Subject: **Additional information for Section 404 Individual Permit and Section 401 Individual Water Quality Certification, Improvements to SR 1733 (Weaver Dairy Road), from NC 86 (Martin Luther King, Jr. Boulevard) to SR 1734 (Erwin Road) Chapel Hill, Orange County, Division 7, Federal Aid No. STP-1733(11); State Project 8.2501601, TIP No. U-3306.**

Reference: NCDOT permit application (March 25, 2009)

**Site 4**

**Site 4**

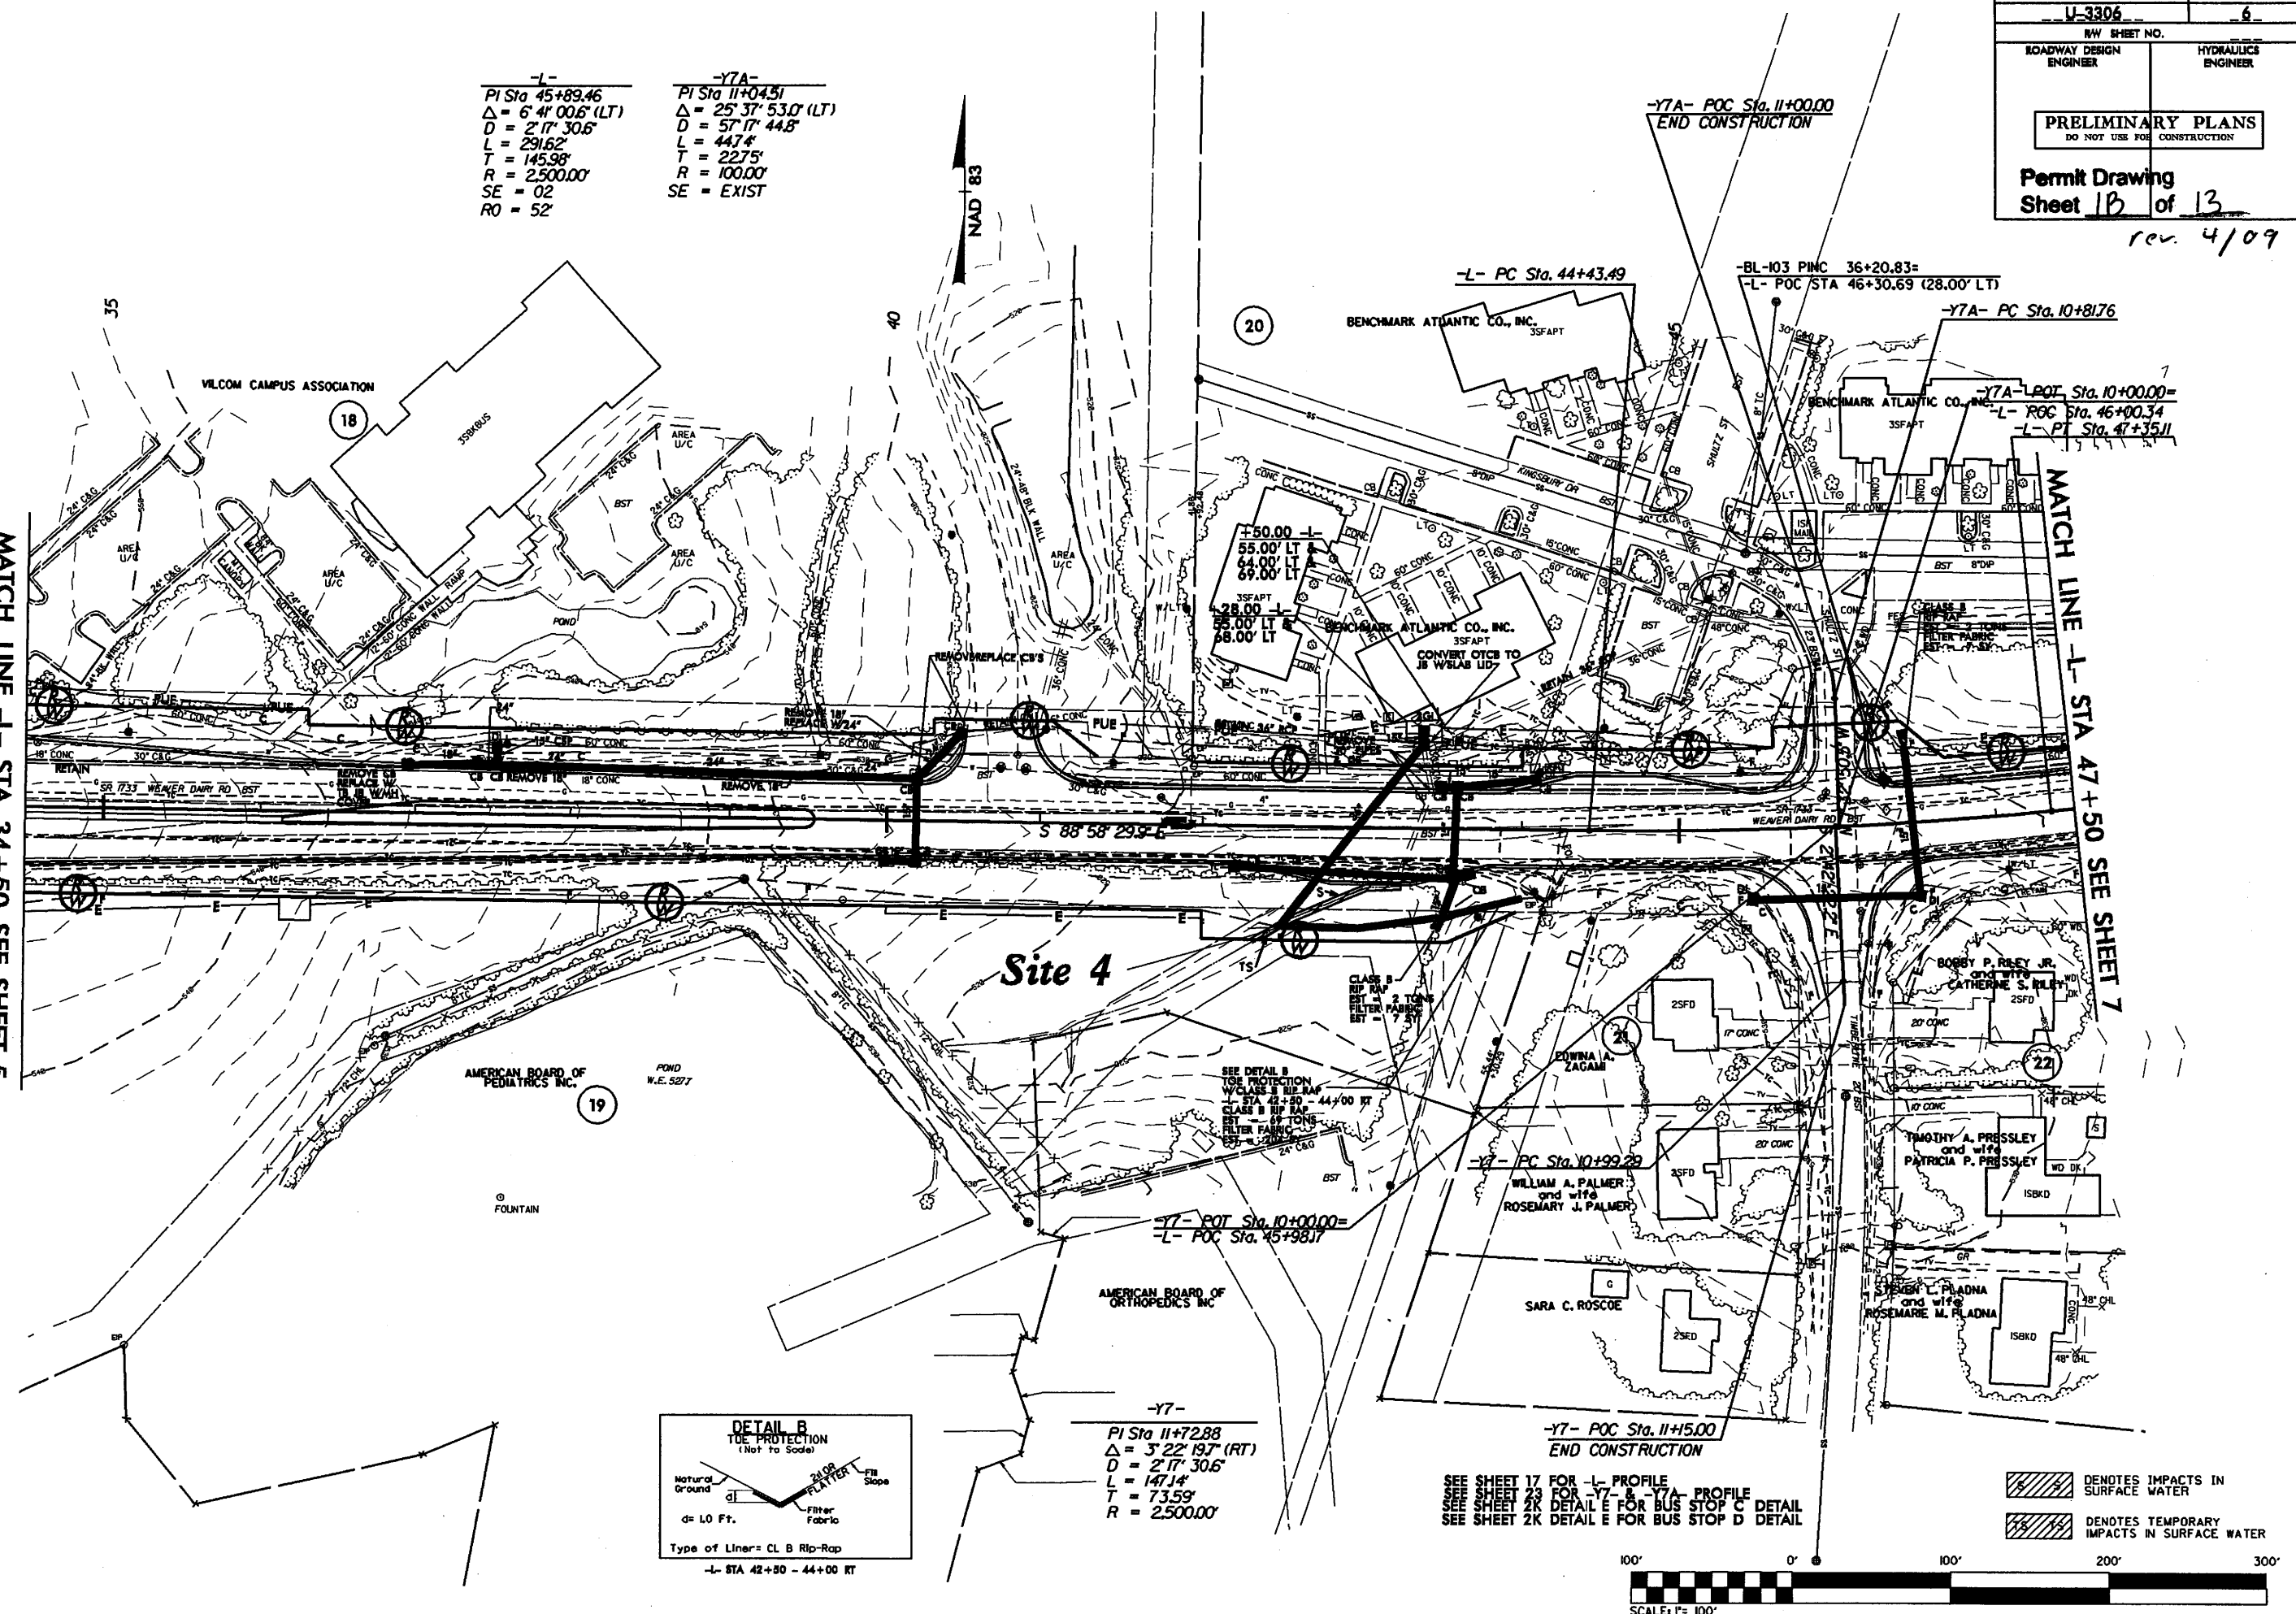
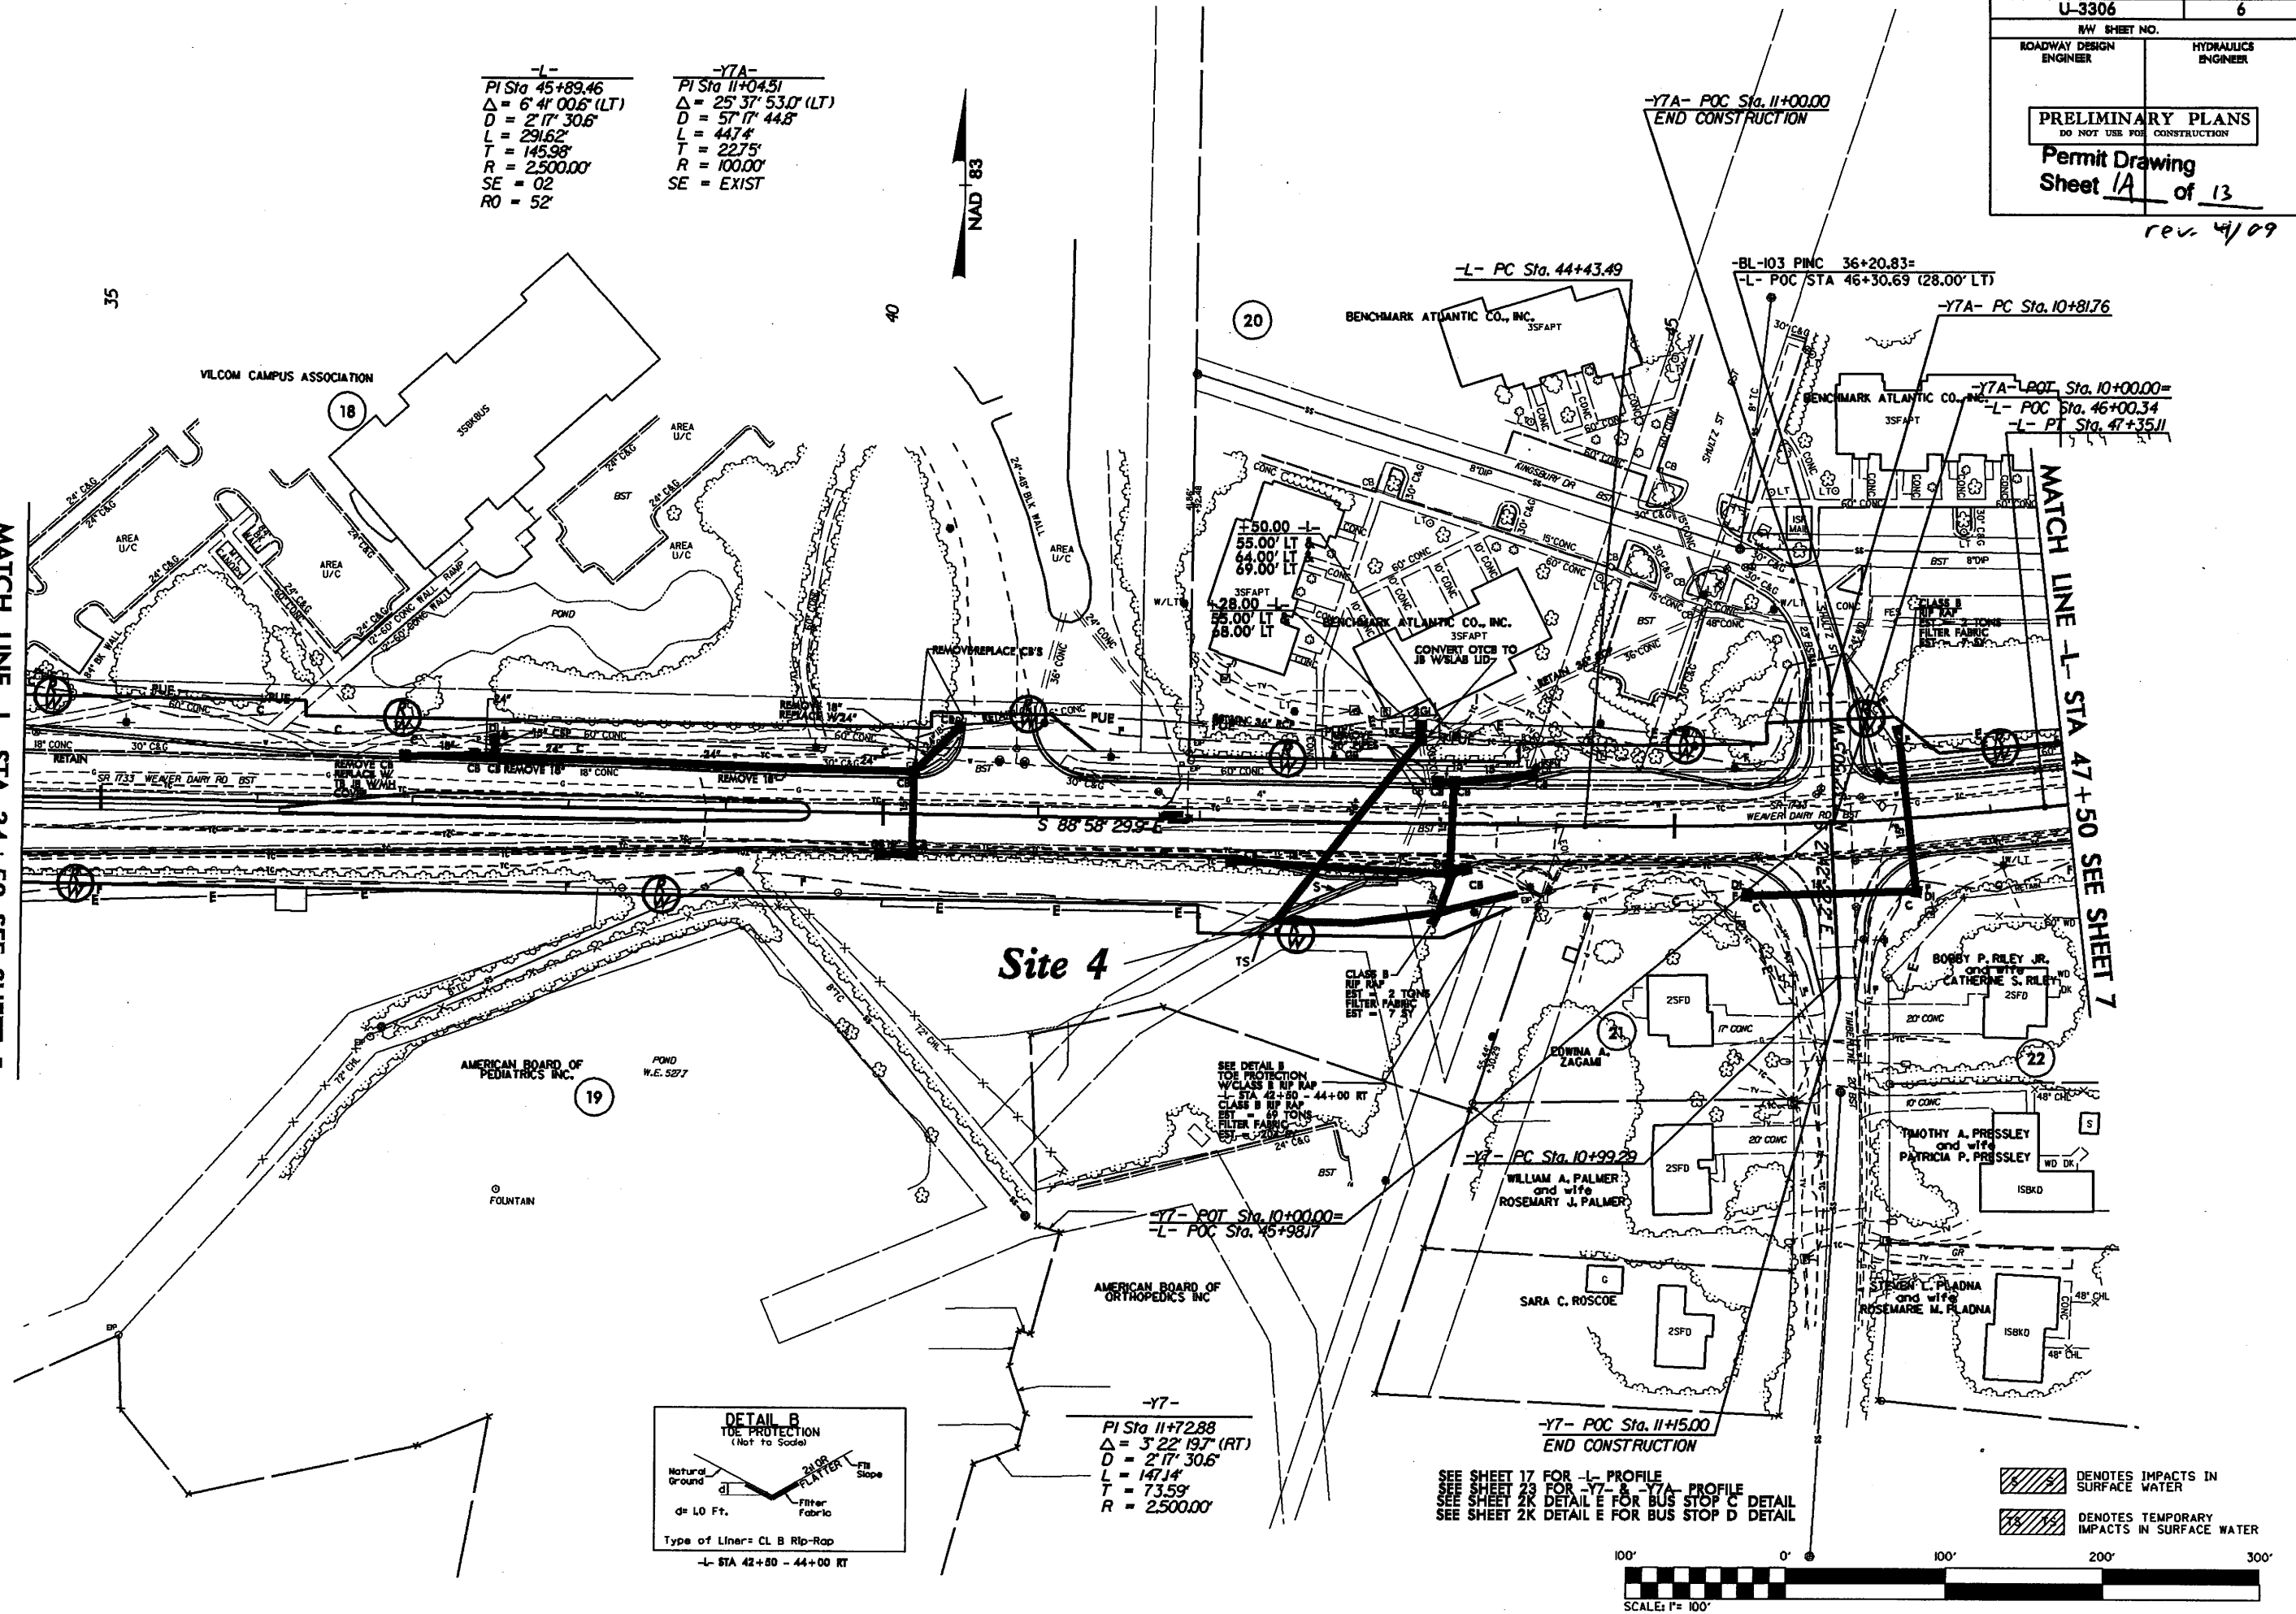
The permanent and temporary impacts to the perennial stream located at station 42+98 RT were not on the permit drawings for the permit application sent on March 25, 2009. The permit drawings have been updated to reflect the impacts both permanent and temporary to this feature. Also, the impacts at this location are now reflected as Site 4.

The construction of a tapered bus stop and a 5-foot sidewalk on the south side of Weaver Dairy Road will result in 83 linear feet of permanent stream impacts and 17 linear feet of temporary impacts at Site 4.
